CITY OF CODY
PLANNING, ZONING AND ADJUSTMENT BOARD
TUESDAY, MARCH 27, 2012
CITY HALL COUNCIL CHAMBERS @ 12:00 NOON

MEETING DATE:	MARCH 27, 2012	TYPE OF ACTION NEEDED	
AGENDA ITEM:		P&Z BOARD APPROVAL:	X
SUBJECT:	NONCONFORMING EXPANSION REQUEST, FERNANDEZ REMODEL SUP 2012-03	RECOMMENDATION TO COUNCIL:	
PREPARED BY:	TODD STOWELL, CITY PLANNER	DISCUSSION ONLY:

MEETING DATE:	MARCH 27, 2012	TYPE OF ACTION NEEDED	
AGENDA ITEM:		P&Z BOARD APPROVAL:	X
SUBJECT:	REVIEW CONCEPTUAL PLAN FOR A 16- LOT SUBDIVISION, GLENN ROSS SUB 2012-01	RECOMMENDATION TO COUNCIL:	
PREPARED BY:	TODD STOWELL, CITY PLANNER	DISCUSSION ONLY:

MEETING DATE:	MARCH 27, 2012	TYPE OF ACTION NEEDED	
AGENDA ITEM:		P&Z BOARD APPROVAL:	X
SUBJECT:	SITE PLAN REVIEW, WYOMING STEEL SERVICES, ROAD 2AB SPR 2012-08	RECOMMENDATION TO COUNCIL:	
PREPARED BY:	TODD STOWELL, CITY PLANNER	DISCUSSION ONLY:

GLENN AND NINA ROSS
CODY, WYOMING
CONCEPTUAL PLAN SHOWING
**PROPOSED GLENN ROSS
MAJOR SUBDIVISION**
IN TRACT 38, T.53 N., R.101 W., 6th P.M.
PARK COUNTY, WYOMING, RESURVEY

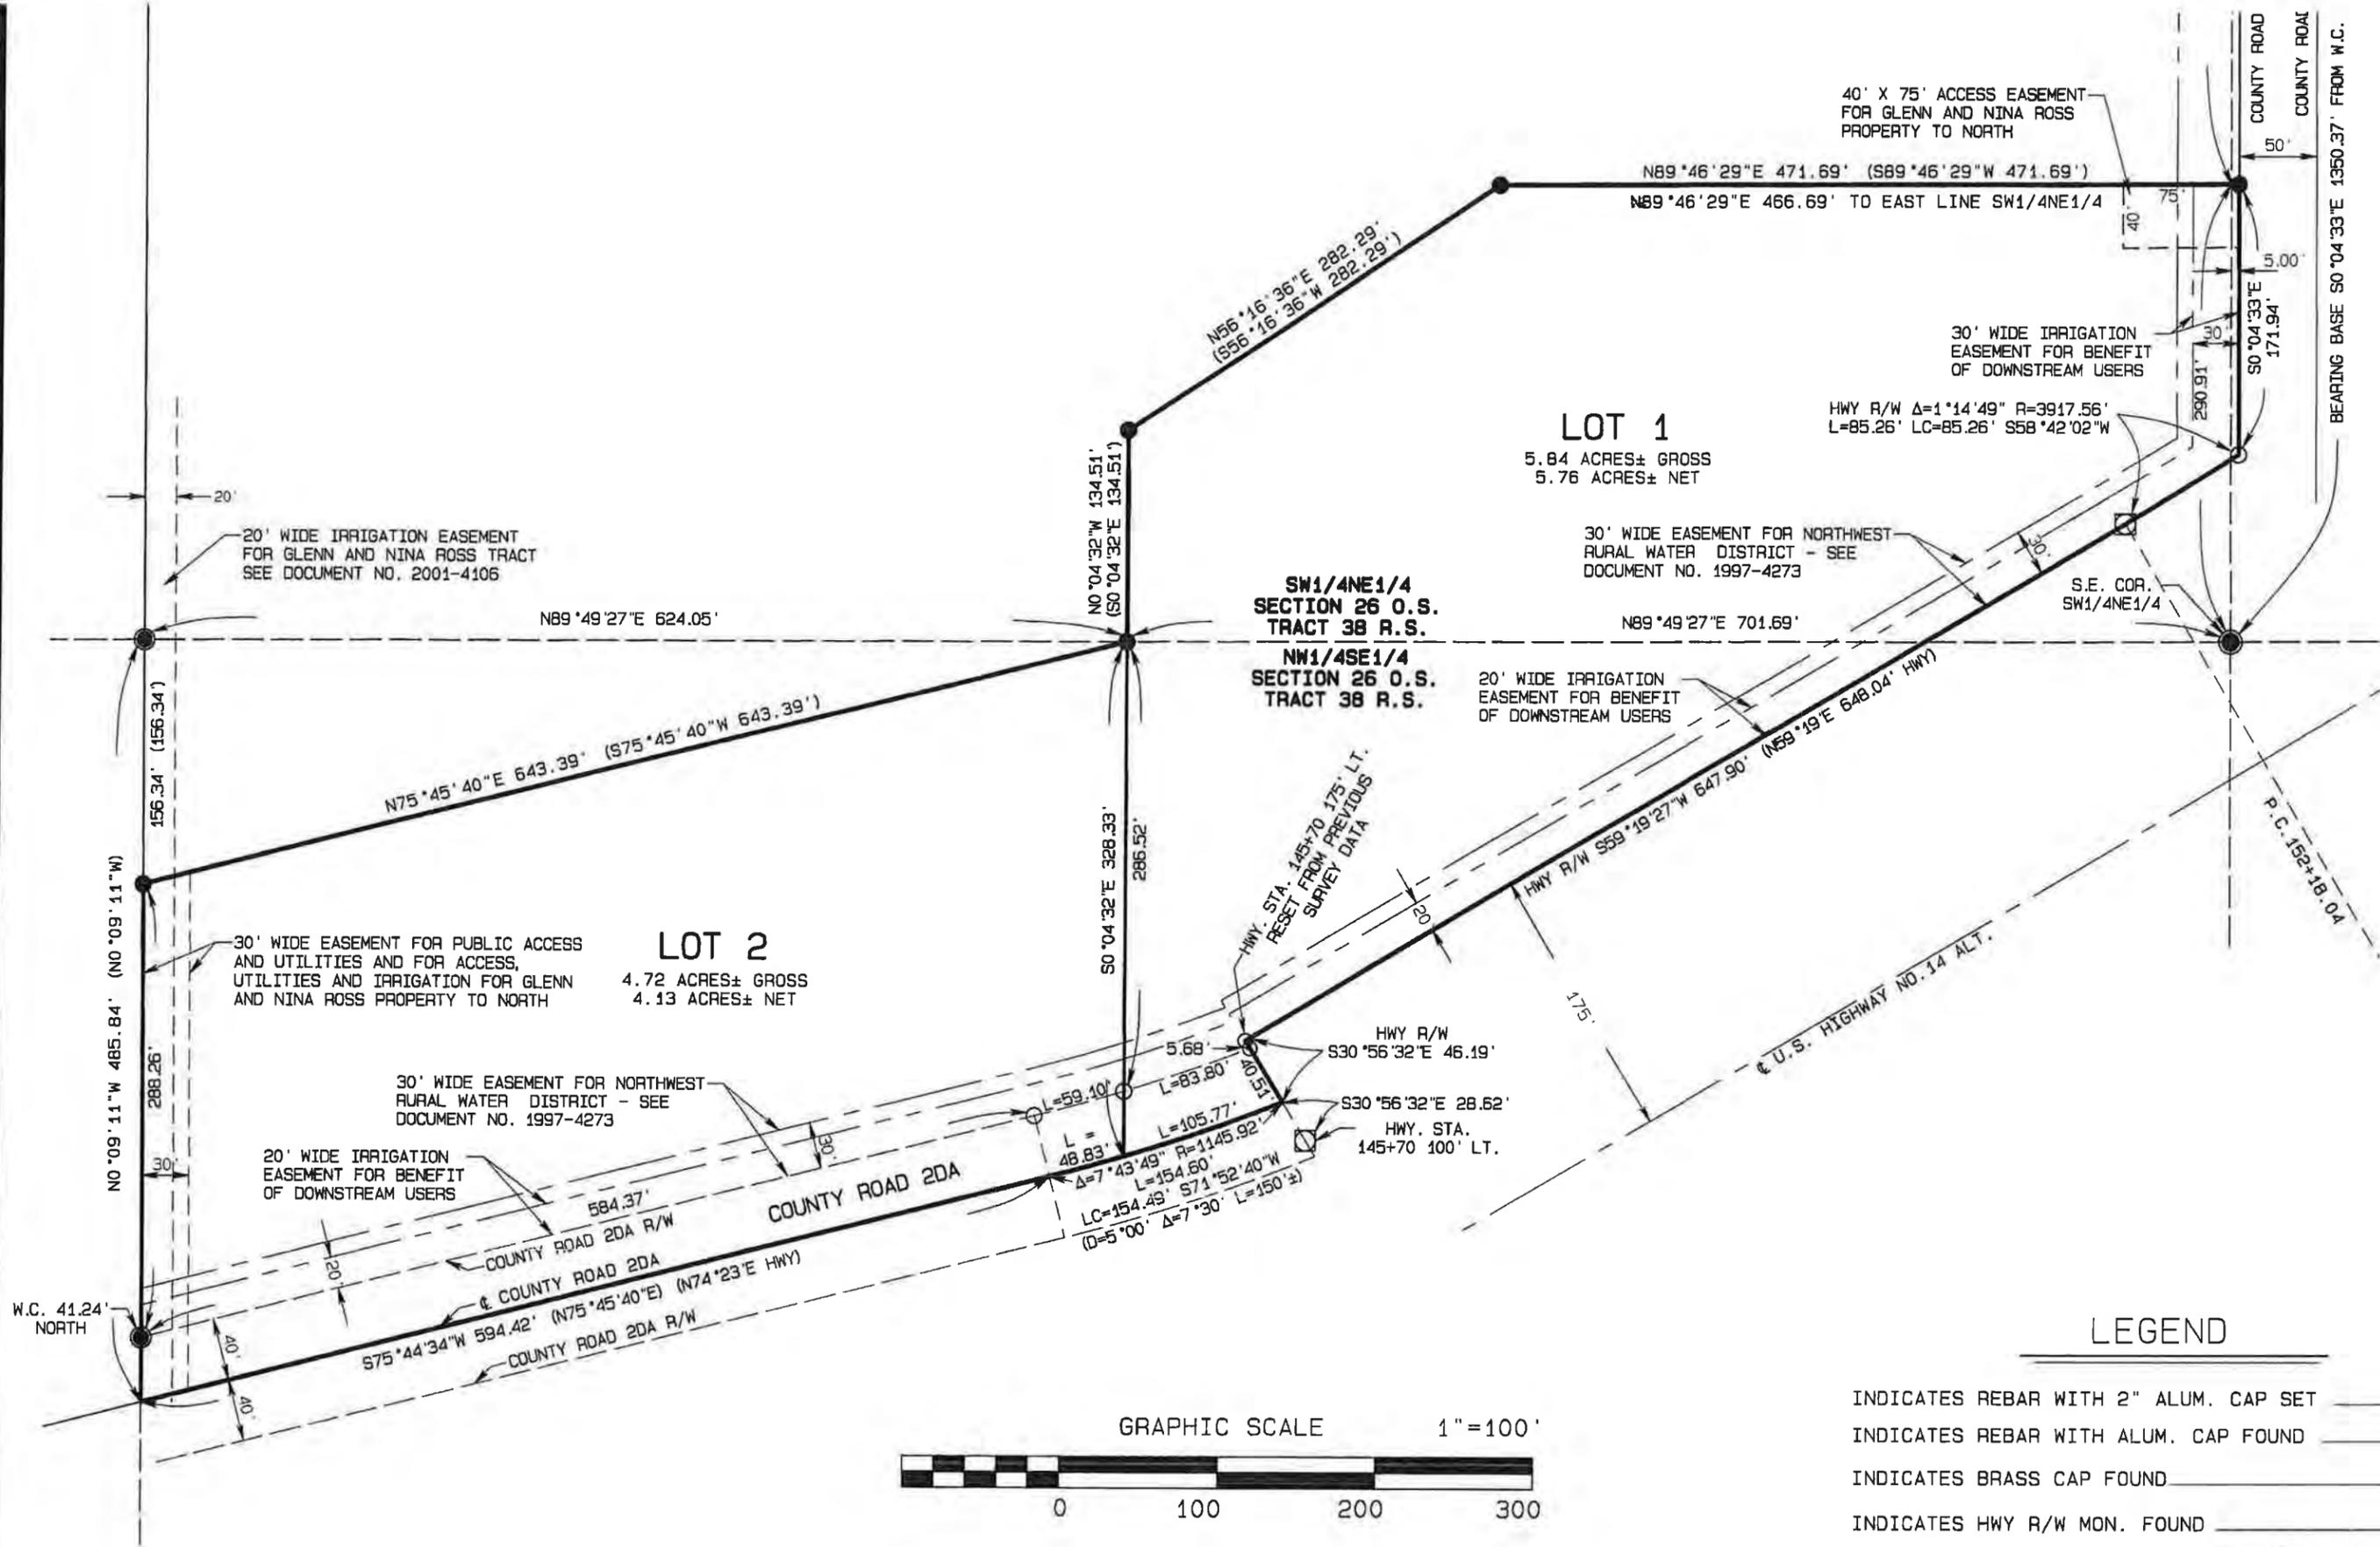
Staff Comment- The proposal does not include any street extensions or intersections that need to align with existing streets.

Staff Comment- A variance from this standard would be necessary to permit the proposed subdivision configuration. In addition, it could be interpreted that an amendment to the Master Street Plan may be necessary if it cannot be shown that the proposal meets the "approximate alignment", which staff interprets to mean the intent and general concept of the street plan. The Board should give direction on this point. A copy of the master street plan is attached. It indicates two north-south streets and one east-west street running through the property.

Staff Comment: The intersection of the interior road with Road 2DA could be tweaked to be at a right angle.

Staff Comment: As proposed, the length of the cul-de-sac at 960 feet does not meet this requirement, which would require a variance. However, if the east-west connection is provided as mentioned above, the "permanent" dead-end would be less than 500 feet, and the standard could be considered to be met.

Staff Comment: The plat will need to be slightly modified to meet this standard. It simply means there will be a little more distance between the curves in the road.

Staff Comment: A variance to the street standard would be necessary to allow the proposed road section.

Staff Comment: Steve Payne, the City Engineer, has discussed the water situation with Northwest Rural Water Company. A 6" main line will be required, and the main line will be required to be "looped", so that there is not a 900'+ dead-end line.

Staff Comment: Street lighting is not proposed, which would require a variance.

Master Site Plan
Wyoming Steel Services, LLC
150 Road 2AB

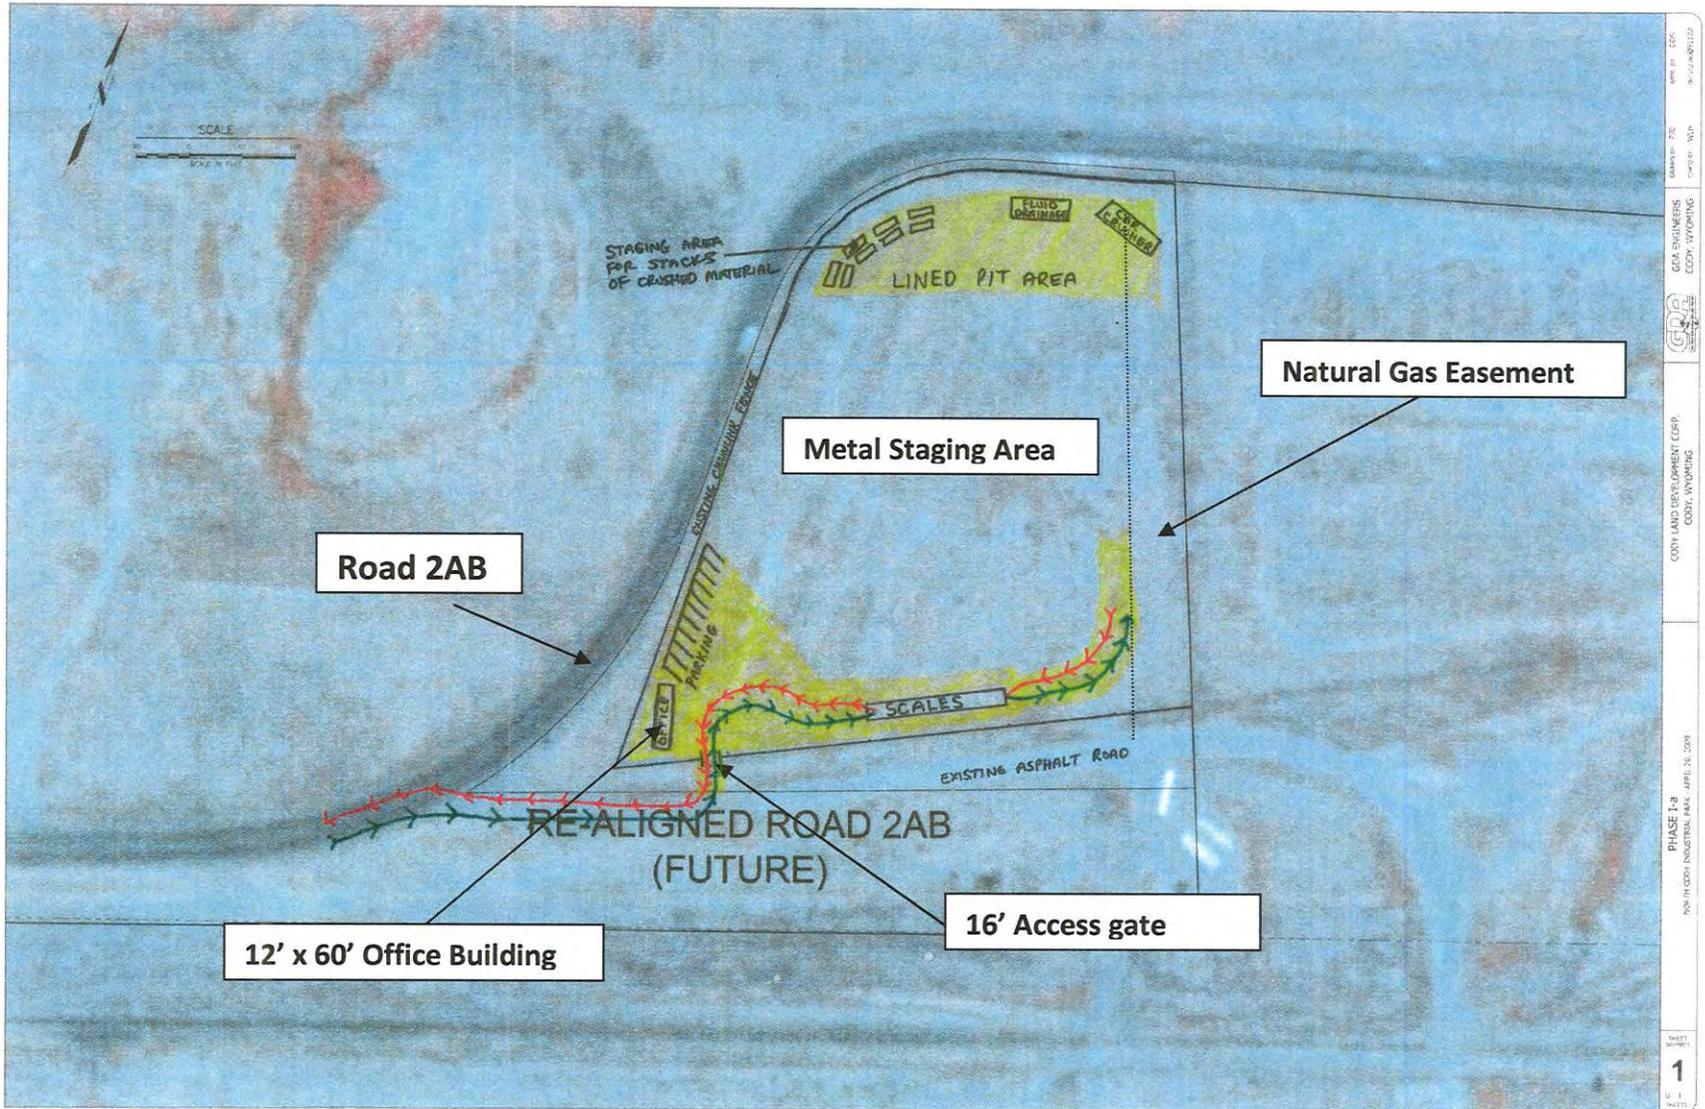
There are natural gas mains and power easements along the east side of the property. It is requested that no items be stored in the easements. The site plan should be amended to reflect this.

Parking is proposed to be a graveled area, as shown on the site plan. The number and location of the spaces is acceptable to staff.

On the map, the area on the north shaded in yellow is the area in which cars will be crushed. As can be seen on the drawing, WSS proposes to excavate 6 inches of soil, place a 6 ml poly liner in the depression and replace the soil. A 4-6 inch lift of gravel will be placed on this fill material.
